# UNITED STATES PATENT AND TRADEMARK OFFICE

APPLICATION NO.	FILING DATE	FIRST NAMED INVENTOR	ATTORNEY DOCKET NO.	CONFIRMATION NO.
10/649,420	08/27/2003	Tim Terakita	10251-001	5301
29391	7590	06/15/2005	EXAMINER	
BEUSSE BROWNLEE WOLTER MORA & MAIRE, P. A. 390 NORTH ORANGE AVENUE SUITE 2500 ORLANDO, FL 32801			WILLIAMS, KENNETH C	
			ART UNIT	PAPER NUMBER
			3739

## Office Action Summary

**DETAILED ACTION*****Election/Restrictions***

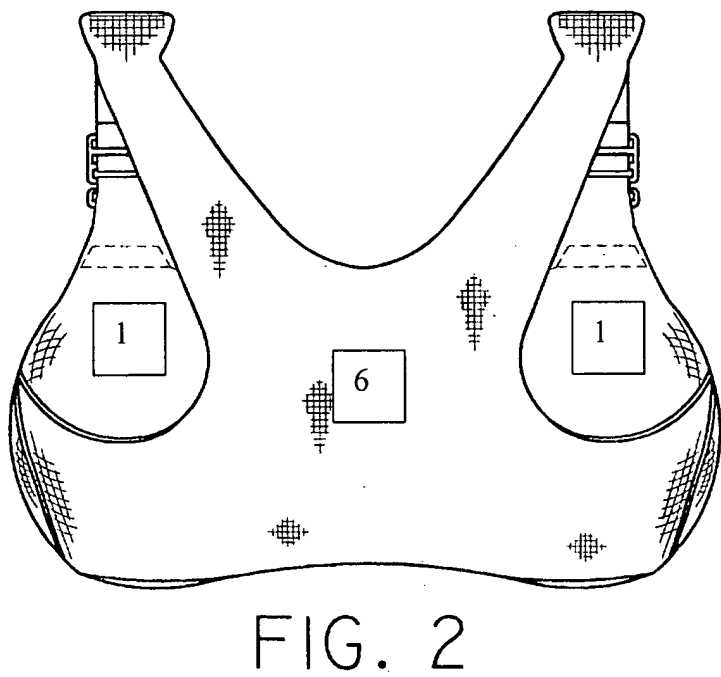
25. In regards to claim 23, Swanger discloses "comprises a first strap having one end connected to said first bra cup and a second end connected to said back panel and a second strap having one end connected to said second bra cup and a second end connected to said back panel" (See Swanger Figure 2 below).

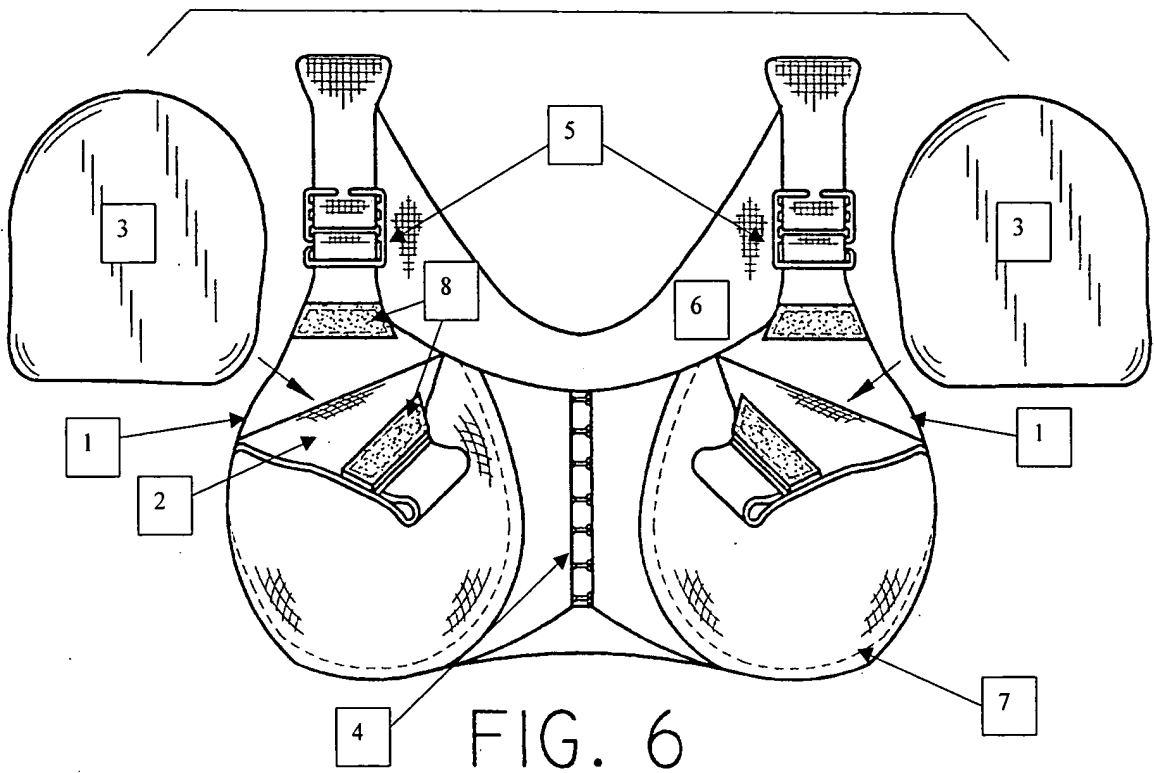
13. In regards to claim 7, Swanger discloses "said certain area of said body comprises at least one of a knee area, a shoulder area, an elbow area, an ankle area, and a mammary gland area." (See Swanger Figure 6 below).

removable first flap positioned over said first front panel." (element 2), "a removable second flap positioned over said second front panel." (element 2), "a therapeutic insert." (element 3), "wherein said therapeutic insert is configured to conform to a breast size." (element 3), "wherein said first front panel, said second front panel, and said back panel are configured so that said breasts are not moved when placing said therapeutic insert between and removing said therapeutic insert from at least one of said first front panel with said first flap and said second front panel with said second flap." (See Swanger Figure 6 below).

16. In regards to claim 12, Swanger discloses "a first strap and a second strap wherein said first strap has a first end connected to said first panel and a second end connected to said back panel and said second strap has a first end connected to said second panel and a second end connected to said back panel" (See Swanger Figure 6 below).

18. In regards to claim 15, Swanger discloses "wherein at least one of said first panel and said second panel comprises two pieces of material wherein an opening is provided between said pieces of material for placement of said therapeutic insert" (See Swanger Figure 6 below, arrows drawn from element 3 show location of opening).

20. In regards to claim 17, Swanger discloses "a therapeutic bra for reducing movement of a breast when applying at least one of a cooling compress and a warming compress to said breast comprising a first bra cup covering a first breast" (element 1), "a second bra cup covering a second breast" (element 1), "a first bra cup flap removable from an outer edge of said first bra cup" (element 2), "a second bra cup flap removable from an outer edge of said second bra cup" (element 2), "a back strap having a first end connected to said first bra cup and a second end connected to said second bra cup" (element 6), "at least one of a cooling compress and a warming compress formed to a shape of at least one of said first breast and said second breast" (element 3), "wherein at least one of said cooling compress and said warming compress fits between at least one of said first bra cup flap connected to said first bra cup and said second bra cup flap connected to said second bra cup" (See Swanger Figure 6 below, arrows drawn from element 3 show location of opening).

therapeutic insert" (See Swanger Figure 6 below, arrows drawn from element 3 show location of opening).
